STAFF REPORT

DATE: 11/4/2020
TO: Mayor & City Council
FROM: Joseph Dodson, Associate Planner
208-884-5533
SUBJECT: FP-2020-0006
Movado No. 9

A final plat consisting of thirty-four (34) building lots, six (6) common lots, and one (1) common drive on 7.47 acres of land in the R-15 zoning district. *This is the ninth and final phase of development of the Movado Estates Subdivision (H-2016-0112).*

MOVADO SUBDIVISION NO. 9
LOCATED IN THE NE1/4 OF SECTION 21,
T. 3 N., R. 1 E., B. 1 M., CITY OF MERIDIAN, ADA COUNTY, IDAHO
2020

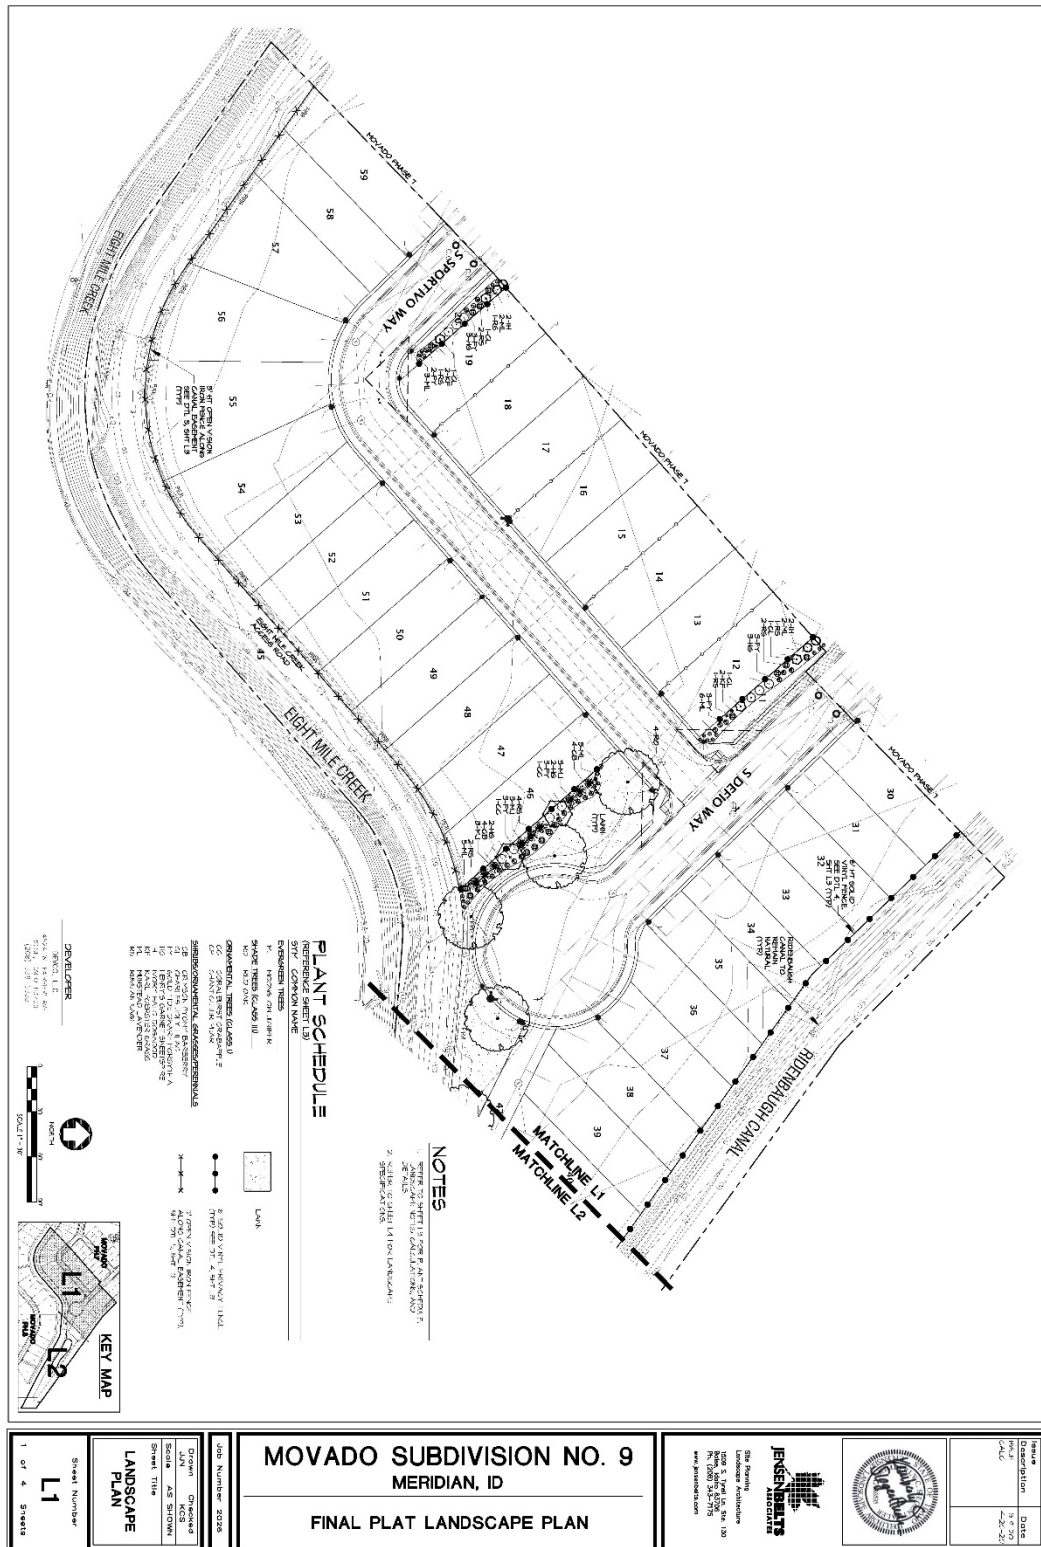
3. Prior to submittal for the City Engineer's signature, have the Certificate of Owners and the accompanying acknowledgement signed and notarized.
4. Prior to signature on the final plat by the City Engineer, the final plat prepared by Sawtooth Land Surveying, LLC (Exhibit B), dated September 16, 2020, shall be revised as follows:

- a. Add a note stating "This subdivision is subject to the provisions contained in City of Meridian Development Agreements Inst. #2017-012608 & 2017-024757.

- b. Note #15: Include recorded access easement instrument number.
 - c. Add a common lot at least 25-feet wide along Cloverdale Road to contain the required landscape buffer.

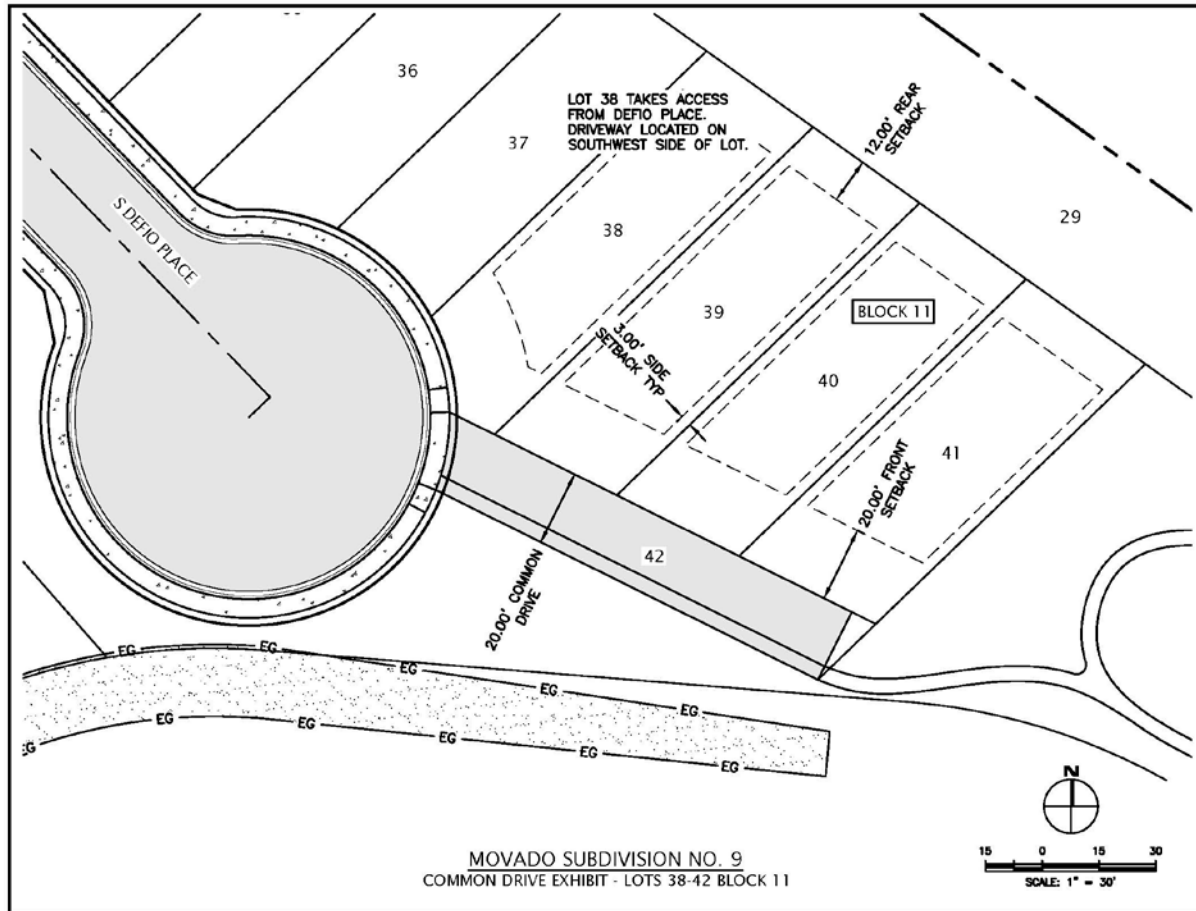
5. Prior to signature on the final plat by the City Engineer, the landscape plan prepared by Jensen Belts Associates (Exhibit C), dated April 20, 2020, shall be revised as follows:

- a. Revise the common open space lot layout of Lots 43 & 44, Block 11 to match the lot layout on the submitted Final Plat and include a common lot for the required landscape buffer along Cloverdale Road.

- b. Show the required 25-foot landscape buffer along Cloverdale Road vegetated per the standards in UDC 11-3B-7.
 - c. Revise the fencing shown along the Ridenbaugh Canal to depict 5-foot open vision fencing as approved with the preliminary plat and as required in UDC 11-3A-7.

- d. Show the proposed amenity in Lot 43, Block 11 to be more consistent with the landscape plan approved with the preliminary plat application and per the approved Development Agreement provisions, and provide an electronic copy of exhibits of the required outdoor fitness equipment as approved with the preliminary plat application to Planning Staff.
